TULSA METROPOLITAN AREA PLANNING COMMISSION

For Meeting No. 2594

January 19, 2011, 1:30 PM 175 East 2nd Street, 2nd Level, One Technology Center **Tulsa City Council Chamber**

The Boulevard - (9428) (CD 6)

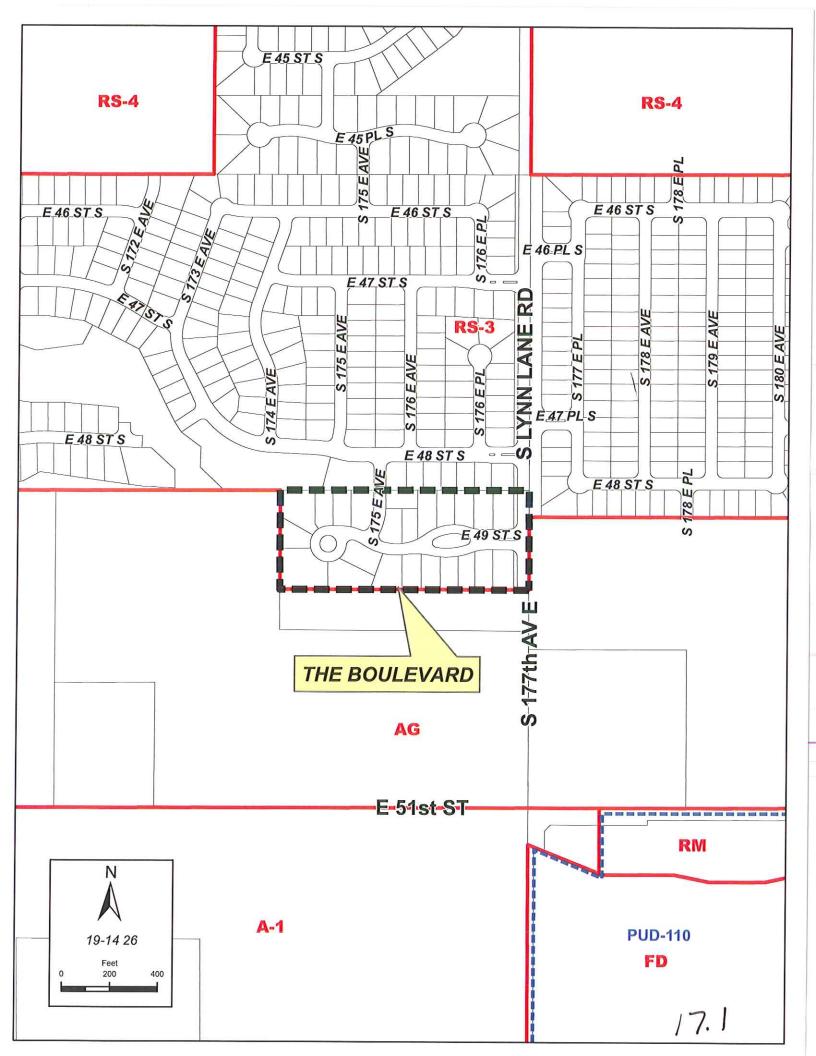
- 1. Zoning: The property is zoned Planned Unit Development 780 (pending), RS-3 underlying existing zoning. The property has previously been platted as Stanford Court and was filed of record in 2005. Public streets with a stub street to connect to the north to the Oxford Park subdivision were planned. The Boulevard proposed a Planned Unit Development with private streets and gates. There is an area of floodplain to the south of the subdivision. The existing subdivision on the site will be vacated. The infrastructure is not in place. With respect to the Tulsa Comprehensive Plan and subdivision connectivity, a stub to the south might be contemplated but there is a floodplain issue. The Oxford Park subdivisions to the north have good existing connectivity. There is commercial or office type of development contemplated to the south in the future. A gate plan should be shown.

- 2. Streets: Reference plat number or book and page number for right-of-way along South 177th East Avenue. Is 175th East Avenue public or private? Show Limits of No Access and access along 177th East Avenue. Show radius for cul de sac. Per subdivision regulations radius must be at least 48 feet for the paving. 175th East Avenue may need to be continued to the south for public connectivity. Separate section required for sidewalks. The section relating to street design and access limitation is not acceptable. Sidewalks must be provided on both sides of 49th Street to 177th East Avenue. Any other configuration requires a waiver from TMAPC. Reference to stub street to the north needs to be deleted if 175th East Avenue is continued to the south. Two car stack length is required from the keypad to the back of curb at 177th East Avenue.

- 3. Sewer: The total utility easement between Lots 8 and 9 and Lot 7 of Block 3 should be at least 22 feet. Continue the 17.5 foot utility easement along the east plat boundary across Reserve A. Add a 15 foot sanitary sewer easement, with the pipe centered within the easement, across South 175th East Avenue. The proposed sanitary sewer extension in Block 1 must be located 7 feet south of the north boundary line. Lots 4 and 5, Block 2, will not be allowed to tap the existing 15 inch for sanitary sewer service. Lot 4 can access the existing 8 inch along the north property line. A mainline extension must be provided to serve Lot 5, Block 2.

- **4. Water:** Show platted waterline and utility/building line easements adjacent to private roadways. Add water line easement language. A looped waterline extension is required. A 10 foot waterline easement adjacent to a utility easement/building line will be acceptable.

- 5. Storm Drainage: All floodplains within multi-lot subdivisions must be placed in a Reserve and an overland drainage easement. Reserve Area 'C' would be acceptable. Section 1.1 must be revised to reflect standard language for an overland drainage easement Reserve Area 'C'. Add a roof drainage subsection to Section I, to require all roof drainage to be piped to Reserve Area 'A', and thence collected and piped to Reserve Area 'B'. The conceptual drainage plan should include pipes and inlets.

- 6. Utilities: Telephone, Electric, Gas, Cable, Pipeline, Others: No comment.
- 7. Other: Fire: Provide fire hydrant coverage per appendix B and C of International Fire Code (2006 edition). GIS: Label all subdivisions within the mile section of the location map (for example Oxford Court). Provide the e-mail address for the surveyor/engineer. Add the date of preparation. Please provide benchmark information. Provide a closer Basis of Bearings. Submit a subdivision control data form. In describing the plat, replace phrases like "due south" and "due north" with actual bearings to match what is shown on the face of the plat. Provide square footage of each lot and reserve. Show address of each lot.
